Technical / News Bulletin

BULLETIN NO.:
TB UK052
DATE ISSUED
03/08/2015

BULLETIN DETAILS			
Product Group:	Power		
Model Effected:	Zippie Salsa R, M and M2		
Effective Date: 01.09.2014	Serial No. Effective From: N/A		
Bulletin Subject:	Zippie Salsa Laterals Update

1" Inset or straight version

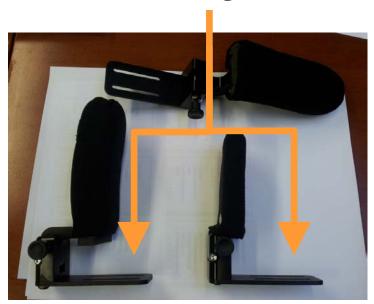
As part of the ongoing product improvement process at Sunrise Medical, the Lateral options provided with the Zippie Salsa family have been updated. The resulting improvements provide a smaller pad, removal of any rotation under pressure, and increased positioning options.

There are two options now available with the new style laterals. These are the standard in-line option and the new 2" inset option, which provides 1" inset for the laterals on both sides.

The new laterals can be retro-fitted to older products, and are available in the spares catalogue.

20003005-125 Swing-away lateral support rigid - small – Pad length 125mm, incl mounting accessories - Pair

20003006-125 Swing-away lateral support inset - small – Pad length 125mm, incl mounting accessories - Pair
